Randwick Local Planning Panel (Public) Meeting

Development Application Report No. D1/24

Subject: 61 The Corso Maroubra (DA/436/2022)

Figure 18: Proposed ground floor landscape plan - 61 The Corso, Maroubra (Source: Bell Landscapes)

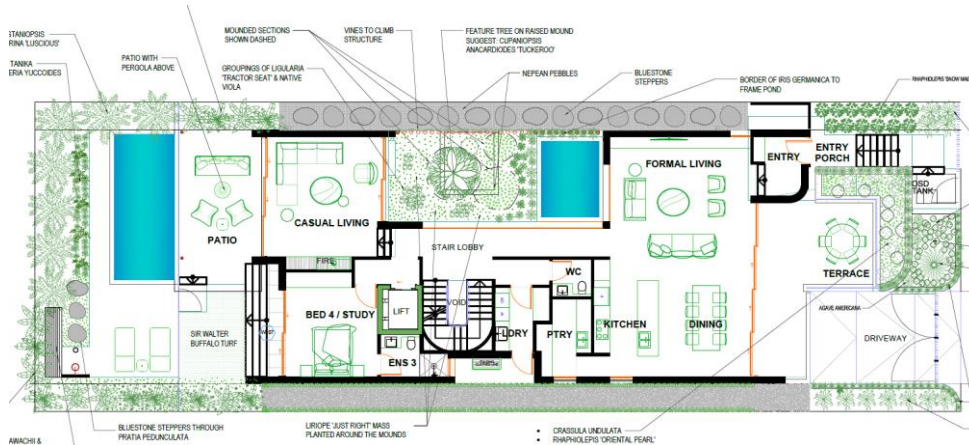
The applicant has identified that there is 32.9% (177.65m²) of the site designed as deep soil area. This area calculation includes some areas less than 900mm in width, both of the side passage along the side of the dwelling, in addition to planters located within the front setback area.

Council has calculated the proposed deep soil permeable area as 18.3% (98.8m²).

The landscaping plan identifies that the north-western side passage comprises of Bluestone steppers and Nepean pebbles. This material detail does not meet the definition of deep soil permeable surfaces. In addition, details of the materials of the south-eastern side passage are not noted on the plan.

Council does not support the subject proposal, as it fails to meet the objectives of the Clause 2.4 of the DCP in that:

- A non-standard condition for an additional 63.1m² of deep soil permeable area, as per the definition of deep soil permeable surfaces in Council’s DCP, shall be provided at the subject site.
- A non-standard condition in relation to the cantilevered dwelling entrance awning adjoining the eastern side of the first floor terrace and planter being reduced to a maximum depth of 800mm, as measured from the external wall of the ground floor entrance.

Figure 19: Proposed first floor plan with Council markings in red - 61 The Corso, Maroubra (Source: PopovBass)

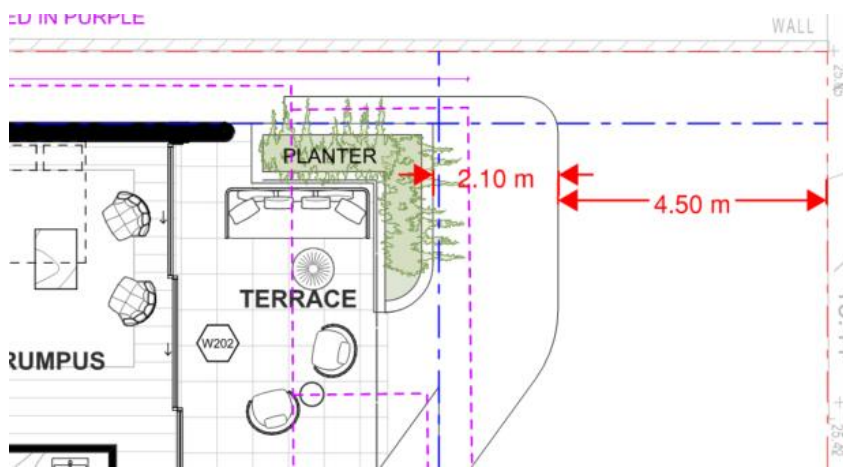
The proposed ground floor external dwelling wall is setback 6.515m from the front boundary, which is consistent with the adjoining dwellings. However, the proposed entrance has a 2.1m-2.7m deep awning that extends forward of the front building line (N.B. there are inconsistencies between the floor plan and elevation, see Figures 19 & 20 below). Council considers that a 2.1m-2.7m deep awning is not a minor projecting feature and therefore constitutes additional built form as a part of the front setback calculation.

Notwithstanding, the proposed unroofed ground level front terrace is only 970mm above the existing ground level and has not been factored into the front setback calculation.

Council is concerned that such a large projecting structure is not in keeping with the streetscape presentation of structures on the south-western side of The Corso. As such, to enable the consideration of this awning as a minor projecting structure, a condition of consent will be issued requiring that the awning is to have a maximum depth of 800mm as measured from the external wall of the ground floor entrance. An 800mm awning will provide further articulation to the front of the dwelling and some protection to occupants from the weather when entering the dwelling, whilst reducing the visual bulk impact of the structure upon the streetscape.

Figure 21: Proposed first floor plan with Council markings in red - 61 The Corso, Maroubra (Source: PopovBass)

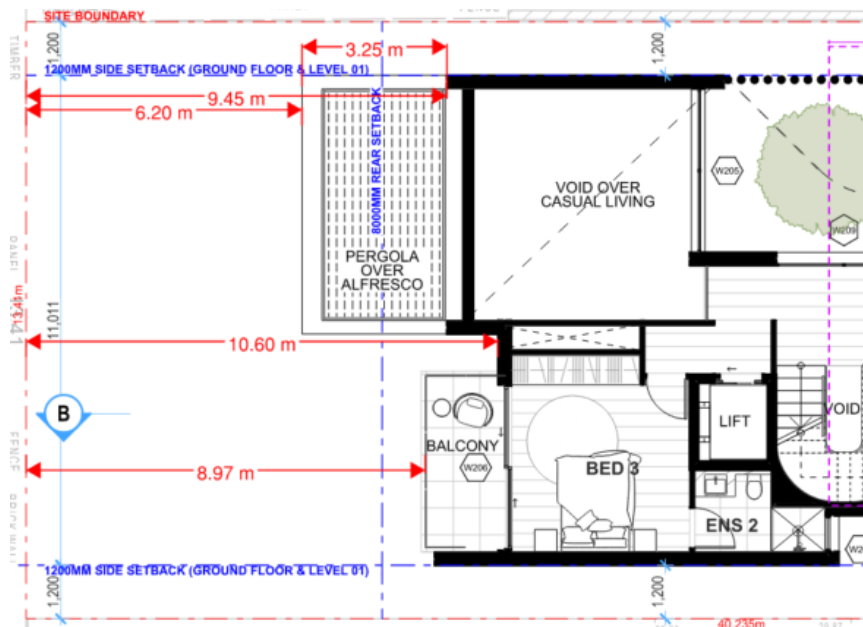
The proposed ground floor external dwelling wall is setback between 9.85m and 10.6m from the rear boundary, which is consistent with the adjoining dwellings and supported by Council. However, the proposed pergola above the ground floor terrace extends 3.25m beyond the rear building line. As such, Council considers that the 3.25m deep pergola is not a minor projecting feature and would form a part of the rear setback calculation. The proposed pergola breaches the beyond the rear setback line of the established urban block of The Corso.

The proposed variation to the rear setback is not supported for the following reasons:

- The proposed pergola is only setback 6.2m from the rear boundary line. Whilst Council notes that there is no predominant rear setback line, the proposed awning will extend further towards the rear boundary line than other dwellings and structures on the south-eastern side of The Corso. Support of such a proposal will compromise the integrity of the rear setback controls and encourage other future development in the block to vary the rear boundary line.

In order for the predominant rear setback line to be maintained and preserved from future variations, as well as to reduce the visual bulk of the proposed awning and retain a sufficient POS area, a condition of consent will be issued requiring that the ground floor rear awning is to have a maximum depth of 1.45m, being setback 8m from the rear boundary line. Compliance with the numerical control should be attained to satisfy the objectives of sufficient separation and a provide compliance with POS area controls.

Figure 23: Aerial view of the subject neighbourhood showing the proposed awning and breach of the predominant rear setback (May 2023) - 61 The Corso, Maroubra (Source: Nearnmap)

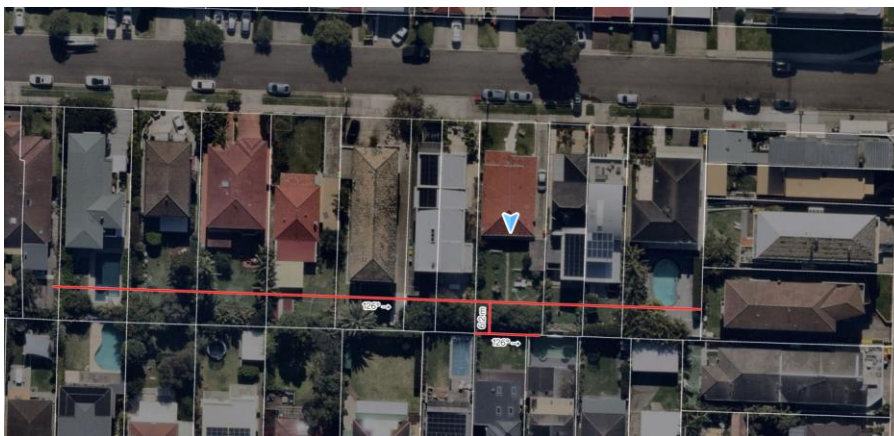
- The most recent development in this urban block regarding the rear setback was at No. 45A The Corso Maroubra where Council supported a 8.8m rear setback single storey extension under DA/926/2015/A (dated 20/07/2016).

Figure 25: Proposed north-east elevation with sight lines in red and adjoining window in pink - 61 The Corso, Maroubra (Source: PopovBass)

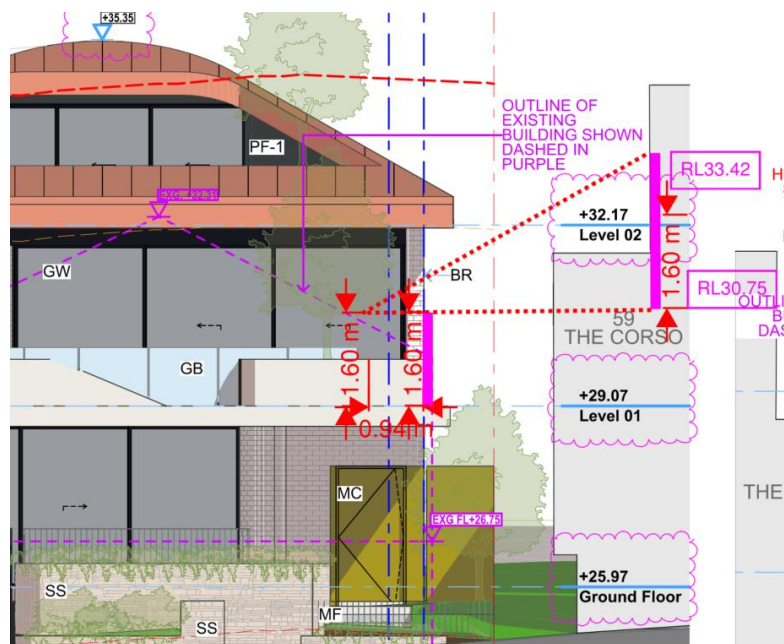
Council is concerned with the interface related to the first floor front terrace adjoining the rumpus room, which will directly overlook an adjacent main bedroom floor-to-ceiling window at No. 59 The Corso. There is a proposed separation of approximately 4.96m between the edge of the trafficable area of the terrace and the first floor bedroom window. The trafficable area of the terrace has incorporated a north-west 940mm planter with a planting area of 630mm that has been implemented by the applicant to manage privacy. The FFL of the terrace is RL29.4 whilst sill height of the floor-to-ceiling window at No. 59 The Corso is RL30.75. As such, the FFL of the proposed terrace is approximately 1.35m lower than that of the adjoining windowsill.

Whilst this south-eastern side bedroom window is already compromised in part by the public domain, the proposed terrace within closer a 5m separation distance presents an unacceptable level of cross viewing. As such, Council is concerned that from the proposed terrace would allow direct sight lines into the adjoining bedroom window, particularly noting that the proposed planter cannot be relied upon for complete privacy mitigation, as outlined in subclause 5.3(v) of the DCP.

Council has considered the requirement for a privacy screen along the north-western side of the terrace to prevent cross-viewing impacts. A 1.6m privacy screen will not prevent overlooking between the terrace and adjoining bedroom window, noting the difference in FFL of approximately 1.68m. See Figure 25 that demonstrates the inefficiency of a privacy screen to prevent overlooking.

Figure 26: Proposed north-east elevation with sight lines in red and adjoining window in pink - 61 The Corso, Maroubra (Source: PopovBass)

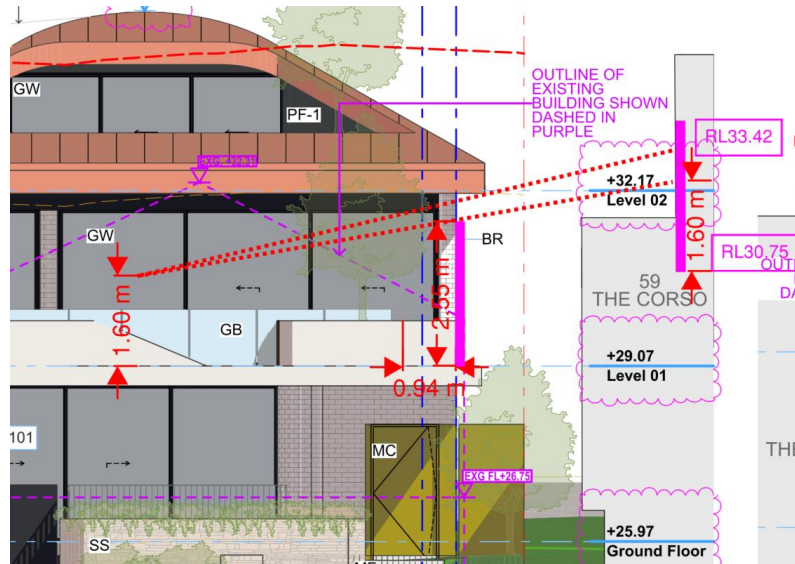
Council also considered the requirement for a higher privacy screen along the north-western side of the terrace that prevents overlooking. The privacy screen would need to be at least 2.55m in height to block a significant portion of overlooking to the window. See Figure 26 below. This privacy screen would not be bound by a roof above resulting in a distracting and non-integrated element of the design, as well as blocking existing water views from the adjoining dwelling to the ocean. As such, Council does not support the addition of any privacy screens within this interface.

Accordingly, to address the overlooking impacts of the proposed balcony, Council will require that the proposed first floor balcony is to be reduced to a maximum depth of 1.5m as measured from the external face of the rumpus sliding doors and 2.8m as measured from the external face of the bedroom 2 sliding doors. The reduced balcony area is to be converted into an additional planter box or non-trafficable roof space.

Figure 27: Proposed first floor addition showing in red the conditioned depth of the terrace - 61 The Corso, Maroubra (Source: PopovBass)

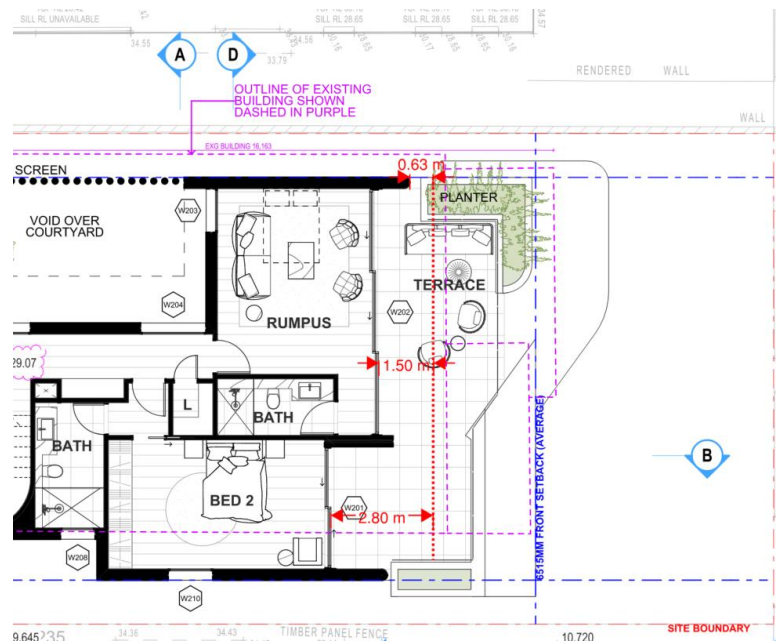
It is noted that a small gap of 630mm between the edge of the dwelling wall and terrace area will remain within this interface, however Council is satisfied that this minor cross-over will not result in

- A non-standard condition to require the first floor front balcony is reduced to a maximum depth of 1.5m, as measured from the external face of the rumpus sliding doors. The deleted portion of the balcony is to be converted into either a planter box treatment or non-trafficable roof space.

Figure 48: Proposed short section with F2C heights by Council in red - 61 The Corso, Maroubra (Source: PopovBass)

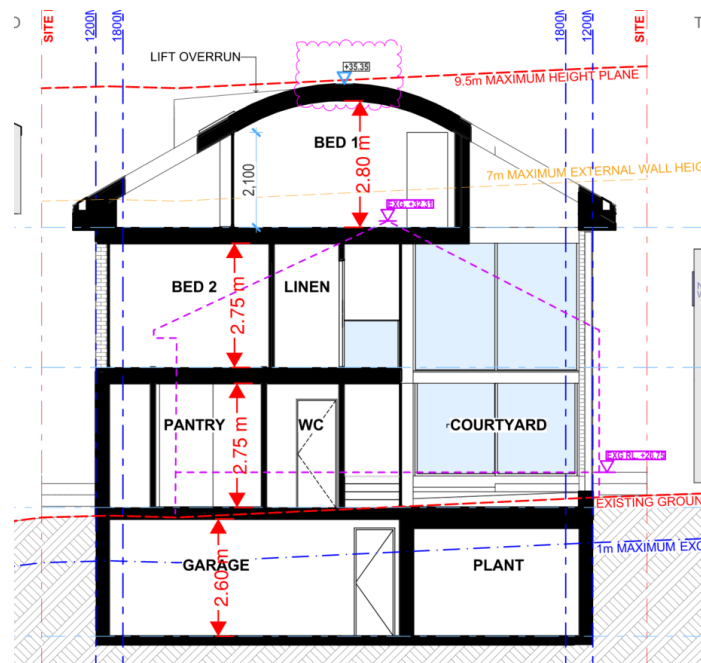
Based on these heights, Council has determined that there is scope within the development to reduce the overall height of the building to match the height of the adjoining flat roof to No. 59 The Corso, being RL34.57.

Between the FFL of the first floor (RL29.07) and the height of the roof at No. 59 The Corso (RL34.57), there is 5.5m. Under the DCP, the minimum floor-to-ceiling height for living areas, such as living room/lounge and dining room, is 2.7m. As the main living areas of the dwelling are located on the ground floor level and the rumpus room to the first floor is a supplementary living room, a minimum floor-to-ceiling height for this floor that adequately provide sufficient amenity to occupants can be 2.4m (complying with Part 10.3 'Room heights' of the NCC 2022). As for the attic floor, to comply with the requirements under Part 10.3 'Room heights' of the NCC 2022, habitable floor space in the attic level must maintain a height of not less than 2.2m for at least two-thirds of the floor area of the room or space. Based on these requirements, Council will require the following conditions to imposed on the development:

Figure 49: Proposed short section showing the conditioned amendments to building height and F2C heights in red - 61 The Corso, Maroubra (Source: PopovBass)

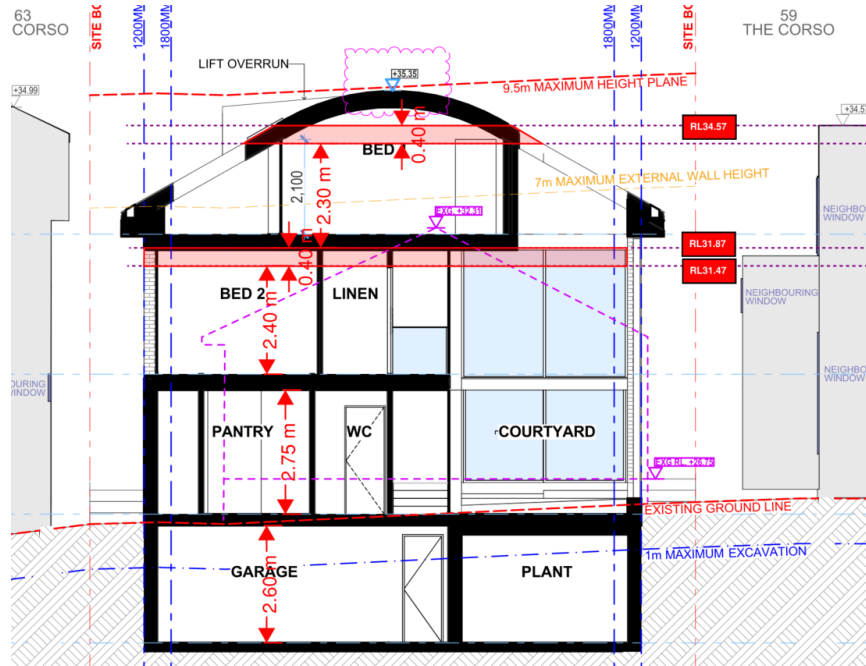
Based on Council's calculations, a reduction of this size will provide sufficient amenity of the proposed dwelling occupants whilst maintaining the views from No's 3 & 4/55 The Corso across the side of the site.

- A non-standard condition to require the overall height of the dwelling and lift overrun is reduced to a maximum height of RL34.57, or alternatively, a revised lift specification is installed that does not require a roof overrun.

- The ceiling height of the first floor level shall have a height of RL31.47 (with the first floor having a floor-to-ceiling height of 2.4m).
- The FFL of the attic level shall have a height of RL31.87.
- The overall height of the dwelling shall be reduced to a maximum height of RL34.57.
